Wiltshire Council Planning Consultation Response

URBAN DESIGN

Application No: PL/2025/09486

Site Address: Land South of Trowbridge

Plot 19 Coppice (WC window only)

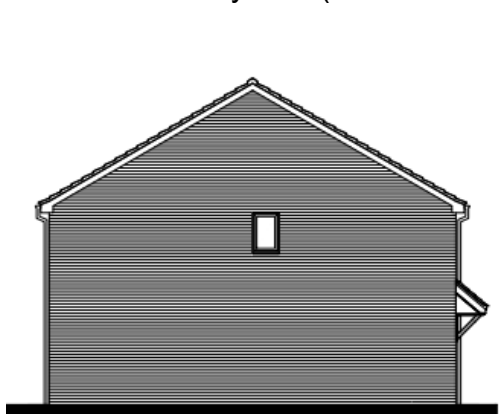
13. Street/street corner return elevations and street/open space corner return elevations have largely attractively placed and proportioned windows utilising house types that are consciously designed for this purpose, but there are the following exceptions below in locations - some marked as 'Key corner turning buildings' on the DPP. These would represent 'what red looks like' BfHL (pp 54-55) rather than the preferred 'what green looks like' (pp 52-53), and WDG expectation 4.2.8. *'Where buildings are on a corner both public elevations should be designed as 'frontages' and have windows from habitable rooms in them'.*

Recommendation: Ensure all key corner-turning buildings have side elevations designed as active frontages, incorporating windows from habitable rooms to enhance natural surveillance, visual quality, and compliance with the DPP and WDG.

Plot 174 Alderwood (WC windows only)

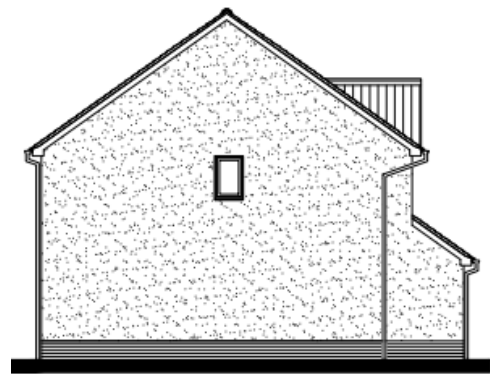
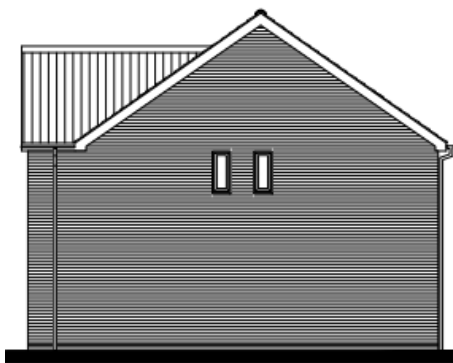
Plot 89/91 etc. Greendale (WC Window only)
